ROLLIN RIDGE Filing No. 1 Grading & Erosion Control Plans El Paso County, Colorado

Remove Filing 1 and replace with
Pre-Development Grading & Erosion Control
Plans.

ROLLIN RIDGE ESTATES - FILING NO. 1

**GEC PLAN
TITLE SHEET**

DETENTION POND B
PLAN & DETAILS

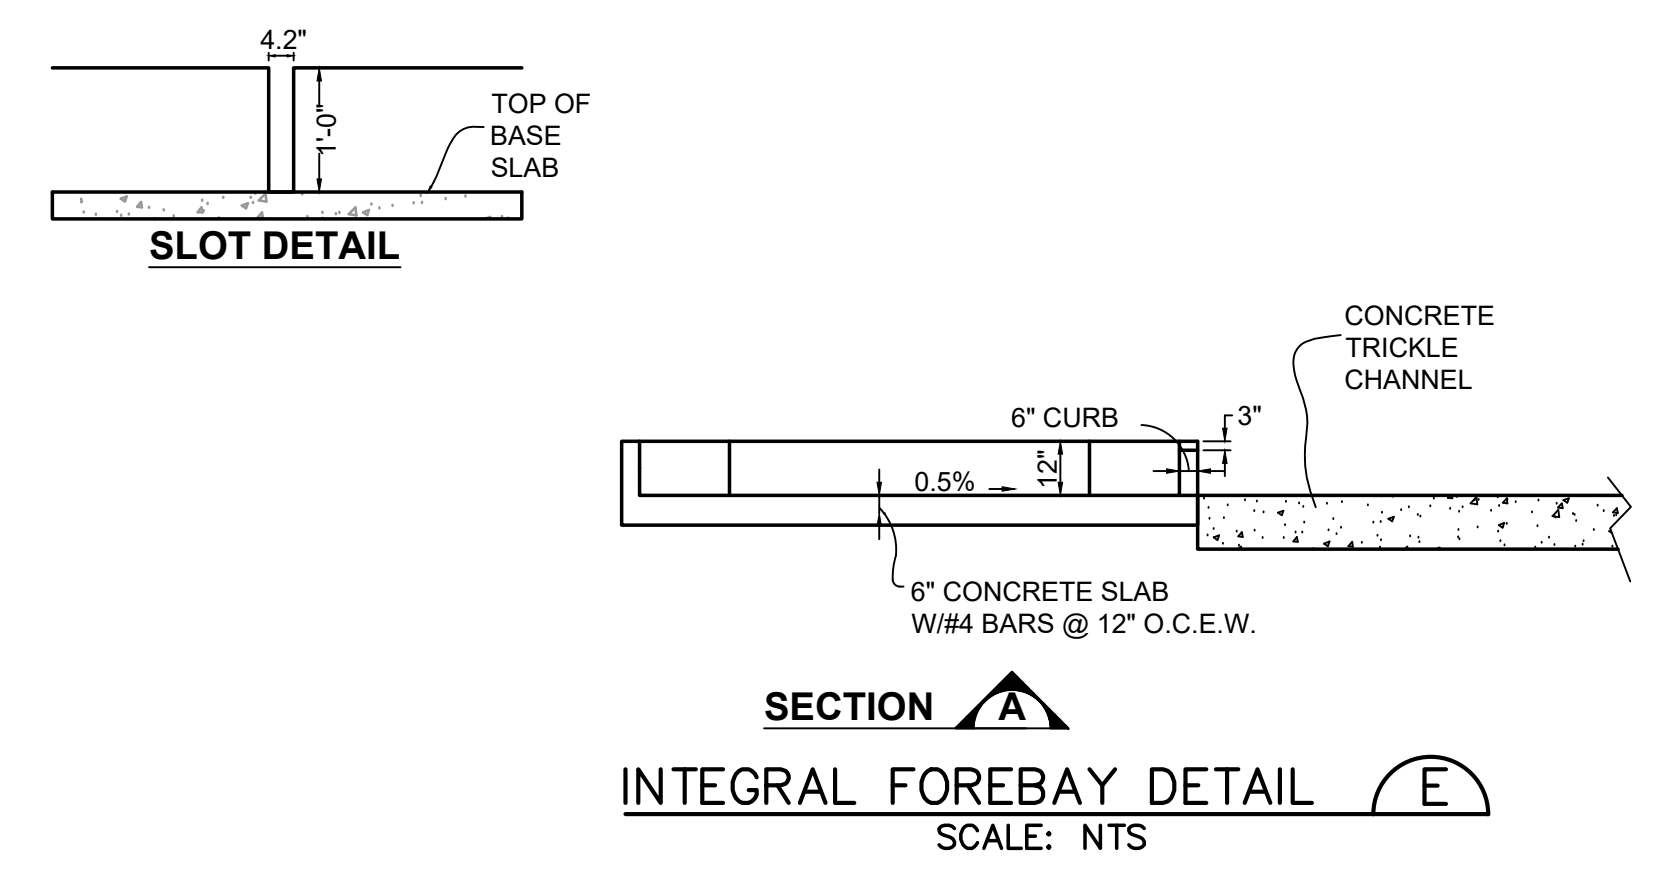
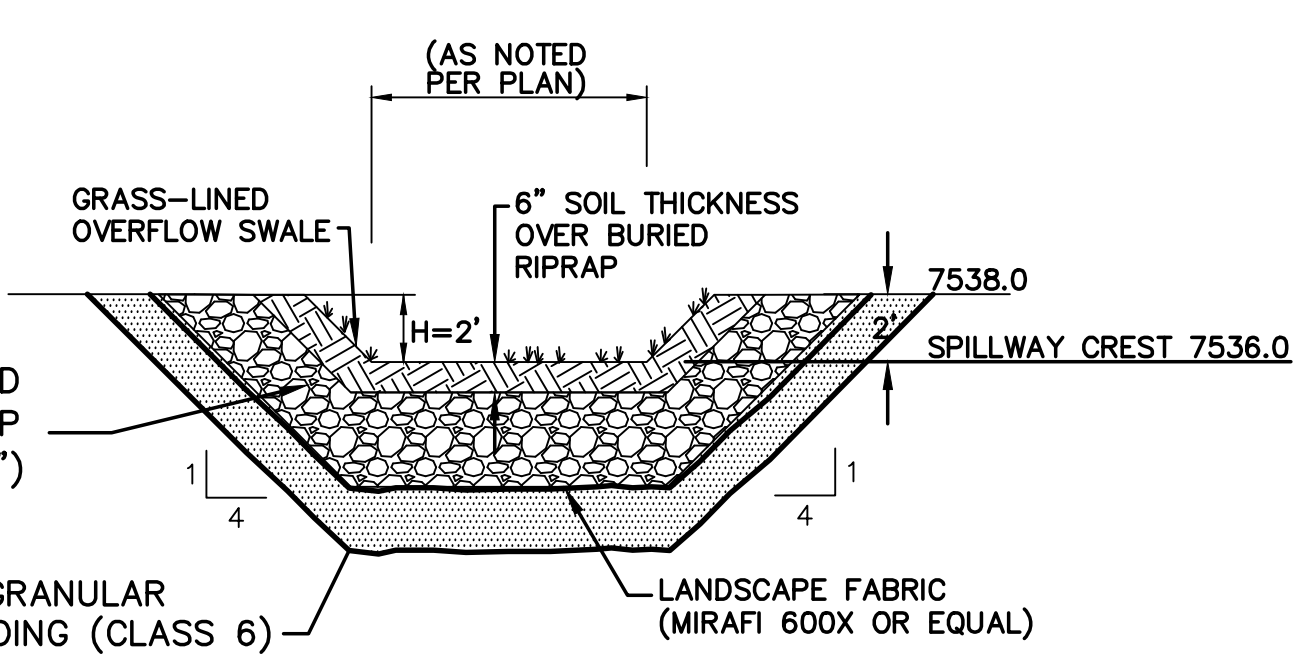
Remove permanent pond outlet structure details. These are approved with the Filing 1 application not the early grading application.
